Ref: JB/JB/2798ma/L004m

Date: 25 Aug 2017

OUTLINE APPLICATION (WITH ALL MATTERS RESERVED APART FROM ACCESS) FOR ROADSIDE SERVICES INCORPORATING A PETROL FILLING STATION WITH ANCILLARY KIOSK AND ASSOCIATED CAR PARKING AND WORKS LAND WEST OF WREXHAM GOLF CLUB, HOLT ROAD, LLANYPWLL, WREXHAM, LL13 9SB

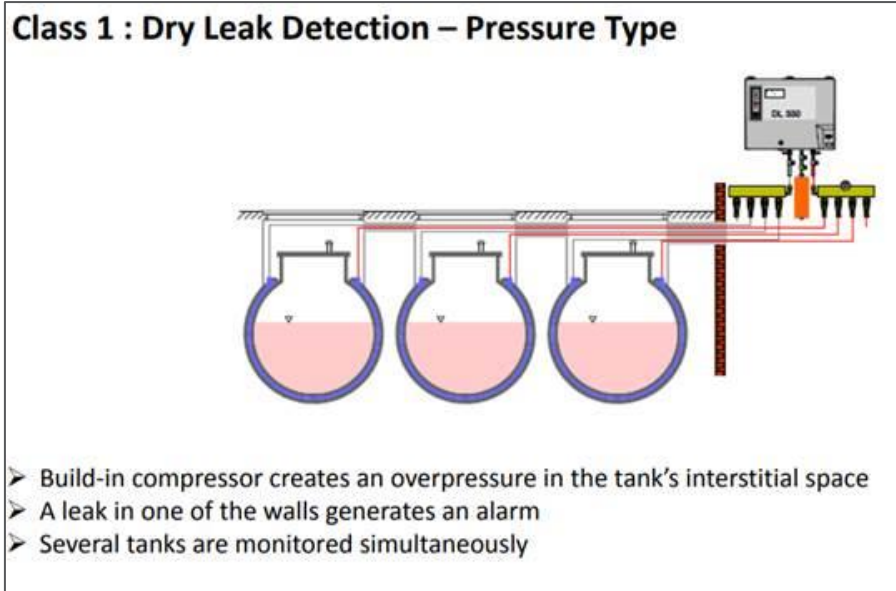
- All of our tanks are double skin steel tanks.
- All of our new to market sites are constructed with a fuel management system which comprises of a Dry Leak Detection System (see image below).

- The above system is constantly monitored but if an alarm is triggered or a failure is detected it is unlikely that any fuel is lost into the ground. When an alarm is triggered it is due to the failure of the outer skin and the fuel is retained within the tank itself (inner skin). However, if this does happen then the fuel is removed from the tank within 4 hours (vacuum tank on site within 1 hour and 2 hours to clear a fuel tank – as an aside, our tanks are never full as we only fill them up for three days of stock which normally means they are half full to $\frac{3}{4}$ full).
